Proposed Revised Technical Specifications

**Changes from the previous August 21, 1997 submittal are identified by margin bars.**

Revised SNEC Facility Updated Safety Analysis Report

UPDATED SAFETY ANALYSIS REPORT  
FOR  
DECOMMISSIONING THE SNEC FACILITY  
REVISION 2

FIGURE 1  
SAXTON NUCLEAR EXPERIMENTAL CORP. FACILITY LAYOUT

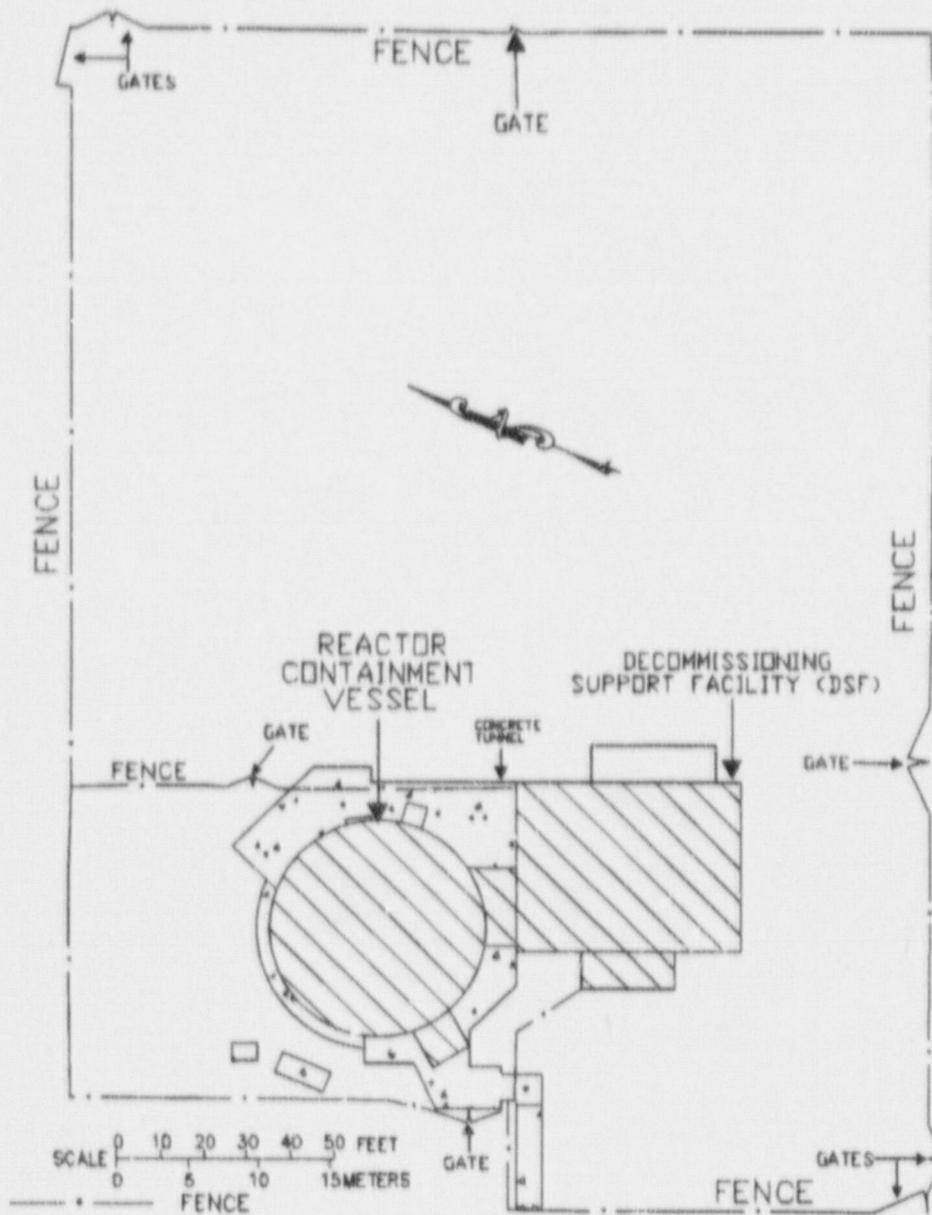
The EXCLUSION AREA consists of that portion of the SNEC facility property enclosed within a fence and building boundaries as posted. See Figure 1.

EXCLUSION AREA - NOTE: The "EXCLUSION AREA" identified by the hatched area is typical and is not meant to represent any specific area, dimension or shape. It will consist, as a minimum, of the Reactor Containment Vessel and may extend to the SNEC outer security fence.

Figure 1-8

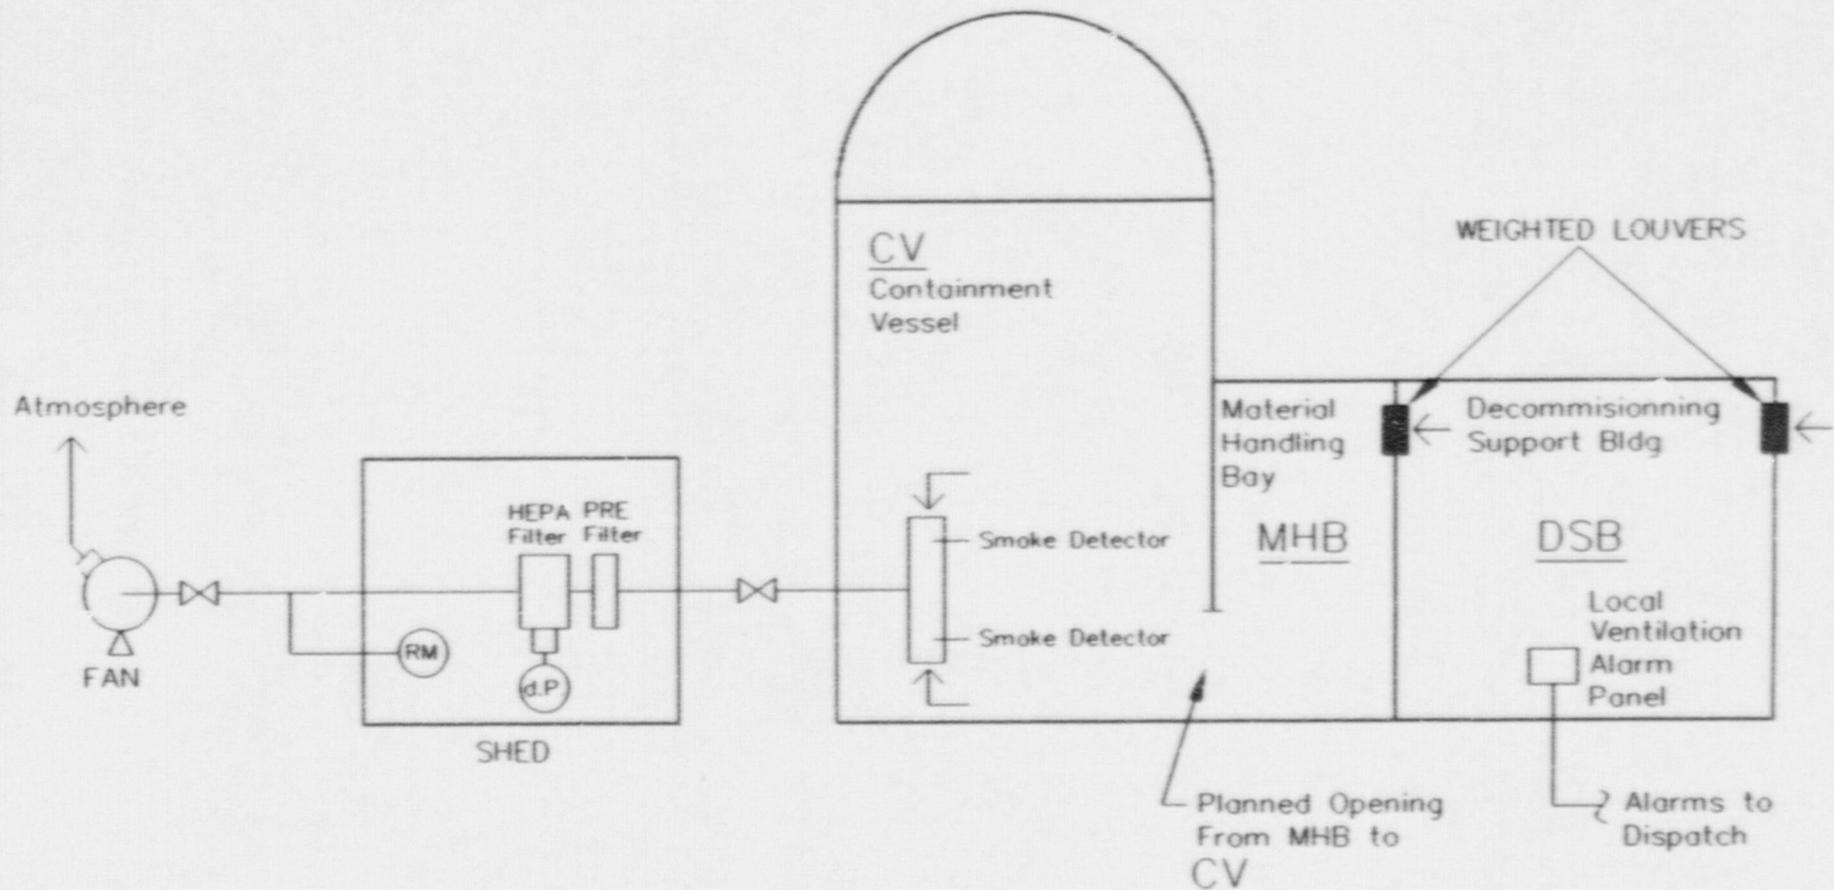
Replace the Title page, page 5 - 2 and Figure 1 - 8 with the revised pages attached.

- (d.P) DIFFERENTIAL PRESSURE - USED FOR LOW FLOW ALARM
- SYSTEM FLOW - NOMINAL 6500 CFM
- HEPA - 99.97% EFFICIENT - TESTING IN ODCM
- (RM) RAD MONITOR - SURVEILLANCE/SETPOINT IN ODCM
